#### APPEAL SUMMARY

<b>Appeal ID:</b> 24529	<b>Project Address:</b> 355 NW 6th Ave
<b>Hearing Date:</b> 1/20/21	<b>Appellant Name:</b> Adam Hostetler
<b>Case No.:</b> B-007	<b>Appellant Phone:</b> 5032342945
<b>Appeal Type:</b> Building	<b>Plans Examiner/Inspector:</b> Brian McCall
<b>Project Type:</b> commercial	<b>Stories:</b> 7 <b>Occupancy:</b> B, R-2 <b>Construction Type:</b> III-B
<b>Building/Business Name:</b> Central City Concern	<b>Fire Sprinklers:</b> Yes - Throughout
<b>Appeal Involves:</b> Erection of a new structure	<b>LUR or Permit Application No.:</b> 20-169364-CO
<b>Plan Submitted Option:</b> pdf [File 1]	<b>Proposed use:</b> PHB Funded Multi-family building with Studio and SRO units and CCC Supportive Services

Project Name: CCC Westwind Apartments	Project Address: 333 NW 6th Avenue Portland, OR 97209
New Construction	Occupancy: A-3, B, M, R-1, R-2, S-1, S-2

## Egress Plans

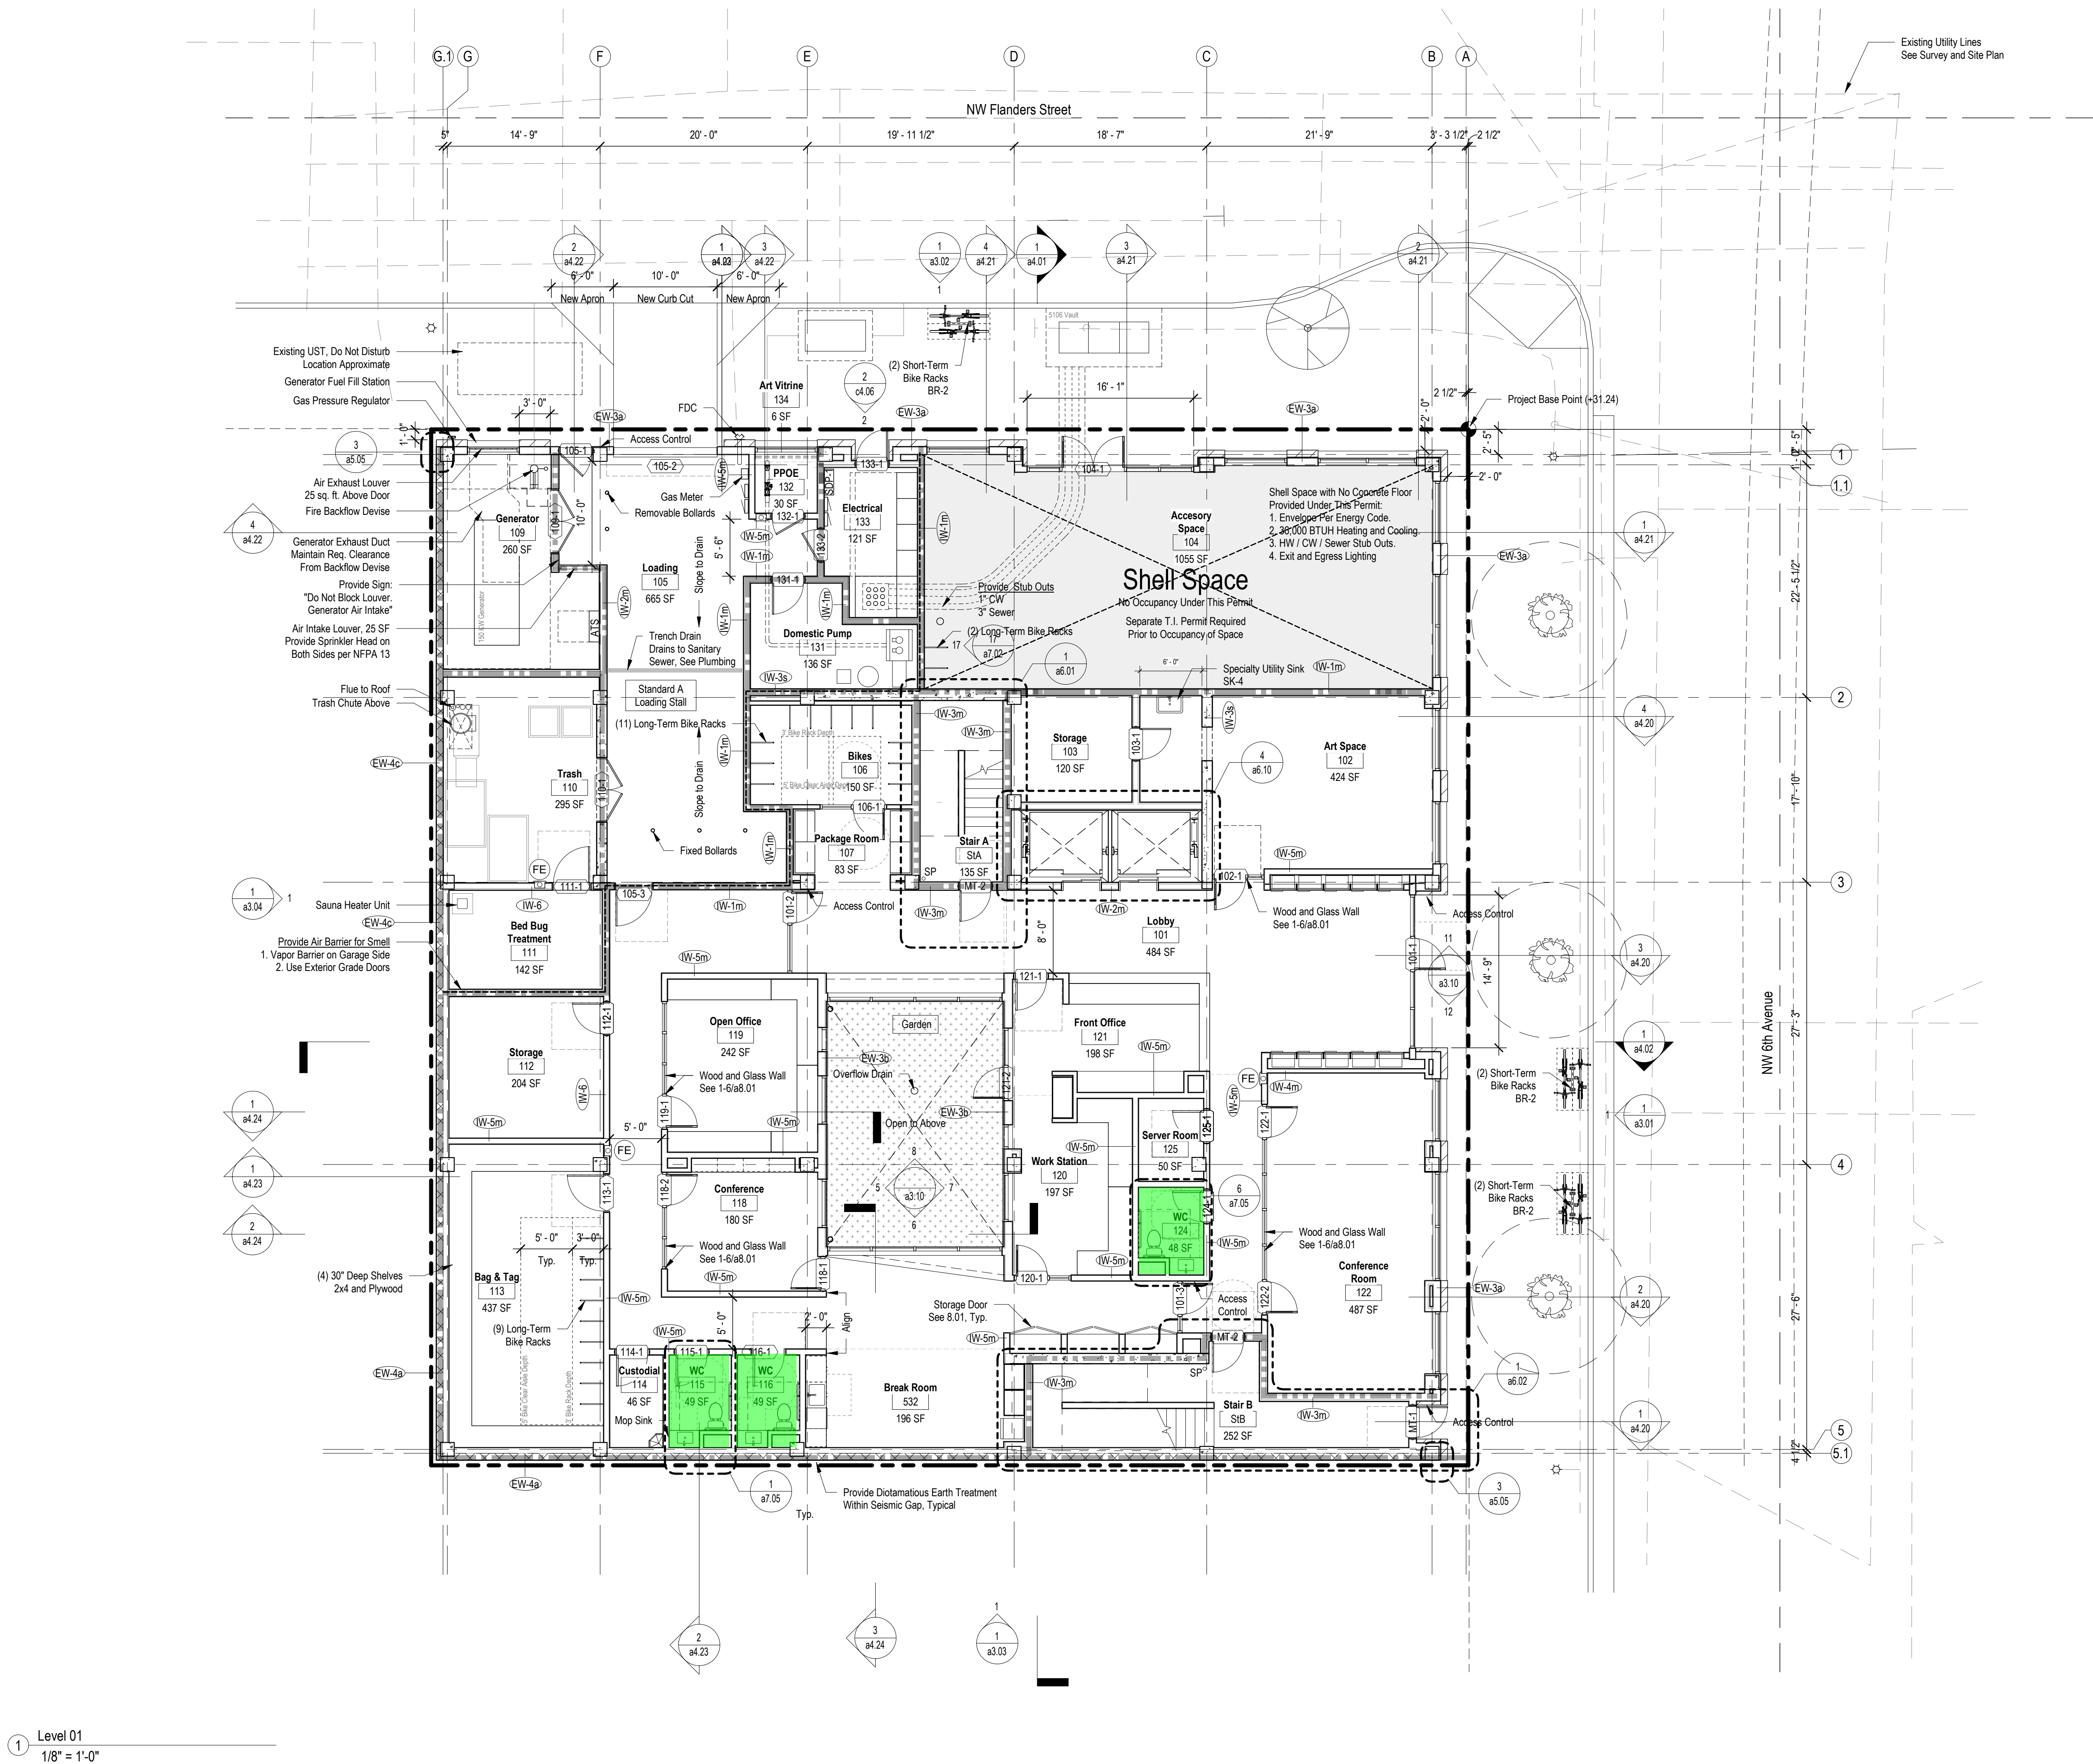
<b>Code Section</b>	Table 2902.1
<b>Requires</b>	The highlighted terrace carries 127 occupants under an A-3 assembly use group. Life Safety reviewer McCall has instructed us to follow the "Restaurants, Banquet Halls, and Food Courts" category per convention on terrace. Per the table, this would require 2 WCs, 1 lavatory, and 1 drinking fountain.
<b>Code Modification or Alternate Requested</b>	Relief from this plumbing fixture requirement. A-3 does not accurately reflect the space's use fixture as it will serve people already living/working in the building, not contribute additional occupants.
<b>Proposed Design</b>	The terrace serves those already living/working in the building. Two public restrooms are provided on this floor with an additional three public restrooms available on the first floor. We suggest that these are sufficient to meet the needs of the terrace.
<b>Reason for alternative</b>	<p>This is primarily a 100-unit supportive housing building and each unit houses a single-occupant. Central City Concern office spaces on the first and second floors are supplemental services for the residents and are only expected to host a handful of full-time employees. The terrace serves those already living/working in the building and the fixture counts accommodate those persons. It is not anticipated that all residents would occupy the terrace at the same time, but if all 100 did, the rest of the building would be vacant and the five public bathrooms would be more than sufficient to serve them per table 2902.1 (1 WC per 75 occs * 5 = 375 occupant capacity).</p> <p>Each unit has a private bathroom. If somehow all public restrooms were overrun, residents could return to their unit to relieve themselves.</p>

**Reduction in minimum required number of plumbing fixtures: Hold for additional information. See note below regarding the process for submitting additional information.**
